## Change in the patient port plug

Correct closing

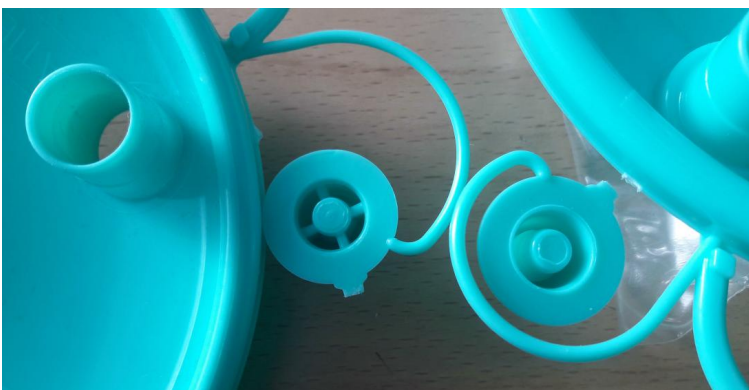
The correct usage of the products is one of the key factors in safety in the hospitals. If come in contact with suctioned liquid the healthcare workers and logistic personnel can expose to many dangerous bloodborne pathogens. Serres suction bags have the most secure closing for safe liquid collection if used properly like shown in the picture below.

If the bag is plugged without removing the patient port, there is an increased risk of leakage.

To minimize that risk Serres will change the design of patient port plug to prevent improper closing. The left plug in the picture below shows the new type of plug.

The first lids with new design will be taken into use this week. The change will come effective step by step while the moulds are modified during their maintenance break. The transition period will be approximately 4 months. During that time both old and new lids are being used in parallel.
